CALIFORNIA COASTAL COMMISSION

**STAFF REPORT: REGULAR CALENDAR**

APPLICATION NUMBER: 5-06-481

PROJECT LOCATION: 121 Catamaran Street, Venice, City of Los Angeles, Los Angeles County.

EXHIBIT # 4

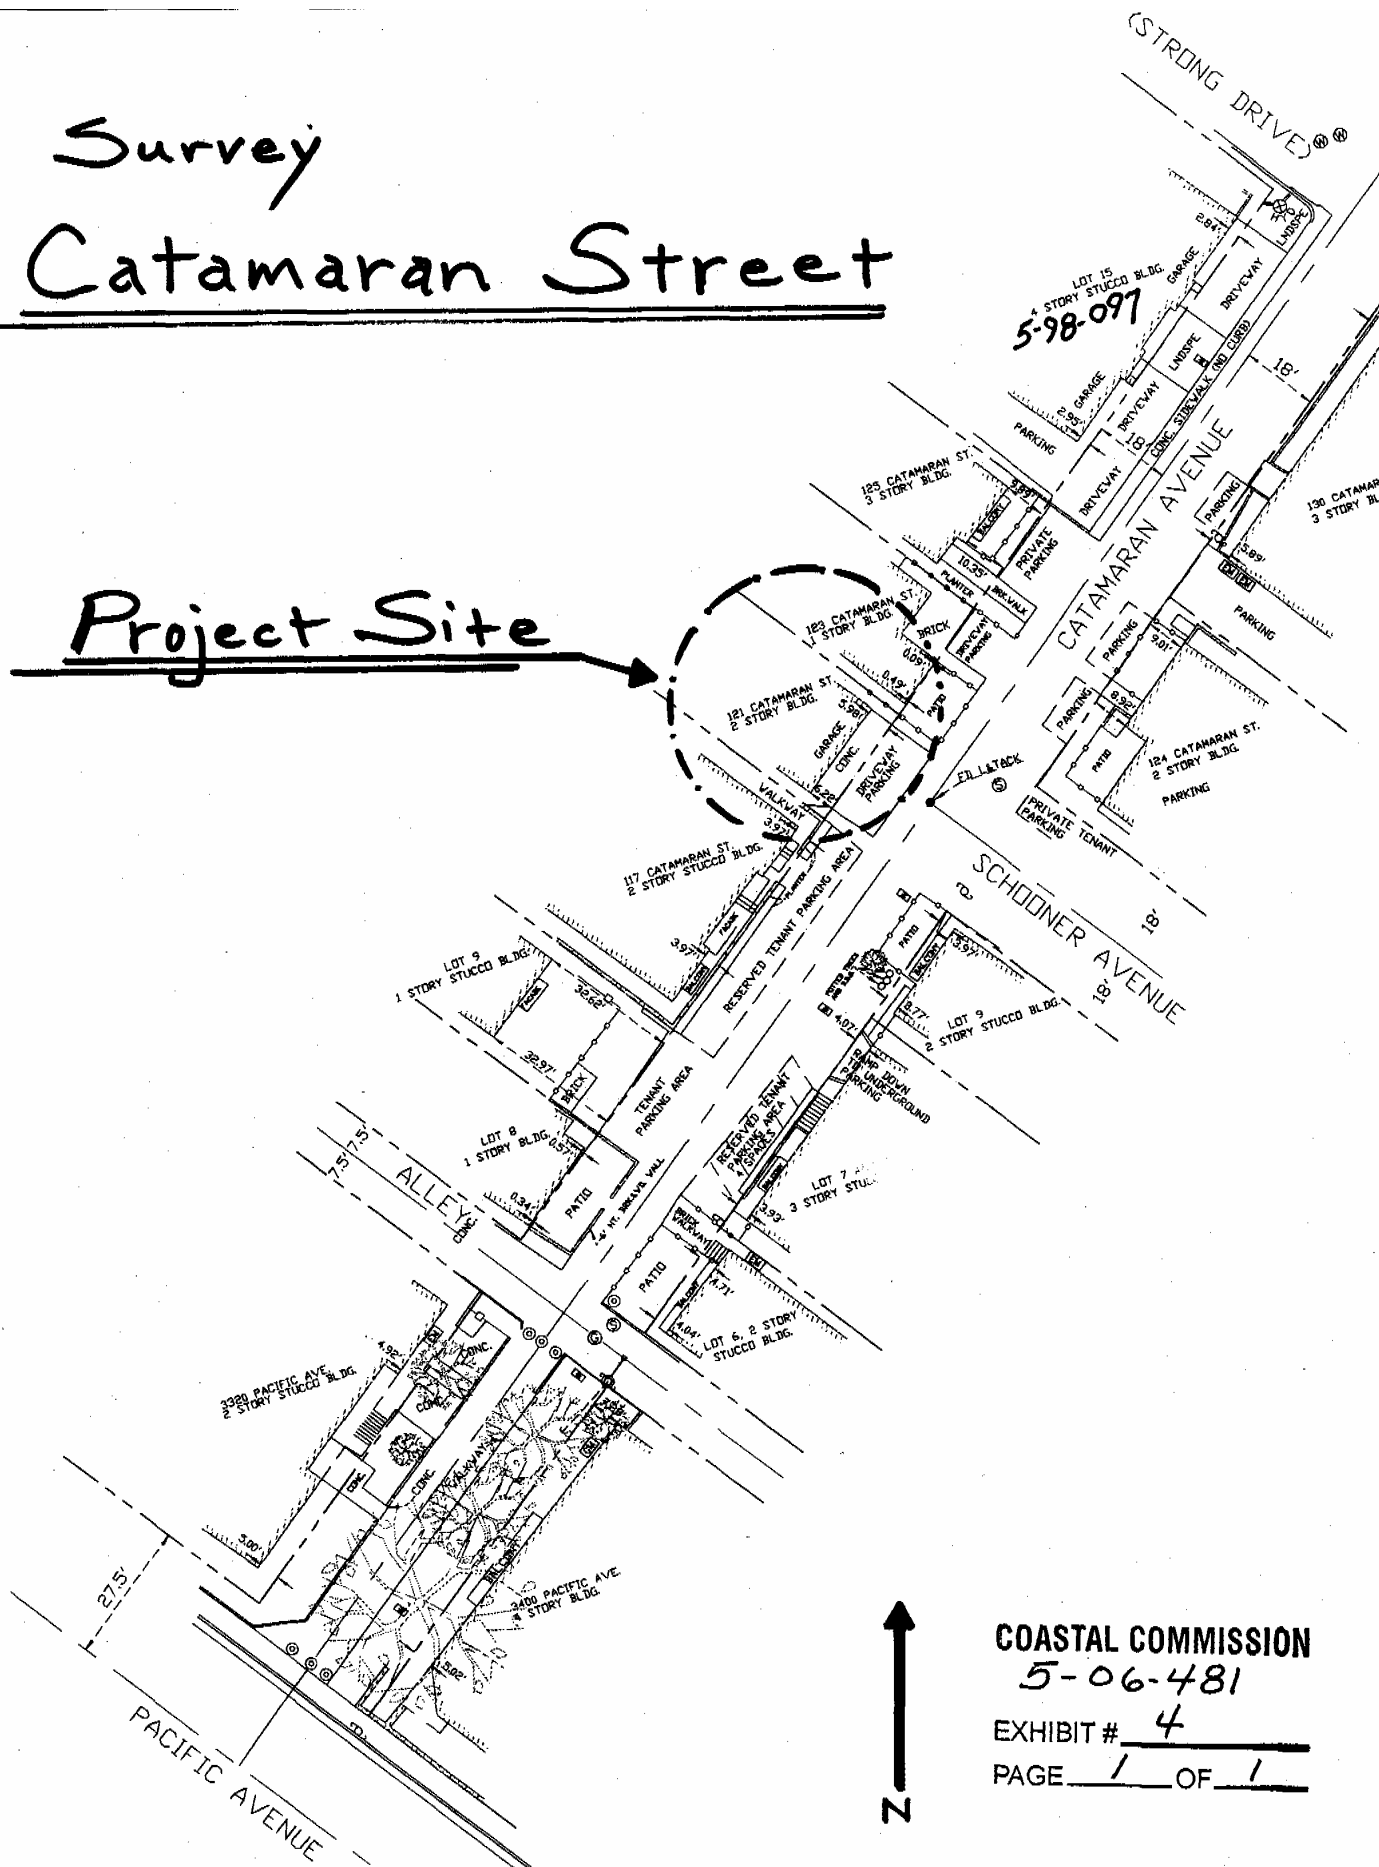
This segment of Catamaran Street (where the project is located) has no curb or sidewalk, and has the characteristics of a wide alley (Exhibit #4). The Catamaran Street public right-of-way near the project site is partly occupied by several patios and fences that encroach into the public way, and also by several parking areas that have been posted with private "Tenant Parking Only" signs that convey a message that the edges of the 36-foot wide right-of-way are private properties (Exhibit #4). The public land is being used by the private property owners and their tenants while denying the general public on-street parking opportunities or other public benefits.

The applicant asserts that no existing public on-street parking will be displaced by the proposed project. This is true, but only because public parking on the Catamaran Street public right-of-way is not currently possible since the edges of the right-of-way are occupied by existing driveways, private encroachments and fences, and public areas are posted with private "Reserved Parking" signs (Exhibit #4). The applicant also points to Coastal Development Permit 5-98-097 (Cunningham) issued for a duplex at the eastern end of Catamaran Street, three lots east of the project site, where the Commission allowed driveway access from Catamaran Street (Exhibit #4). But that was one case where it was not feasible to have the driveway come from the rear alley because the lot has no alley access; it fronts on Strongs Drive, a public street that is regularly used by beach goers and neighborhood residents for on-street parking. The driveway for that project had to be provided by either Catamaran Street or Strongs Drive, since there was no alley option.
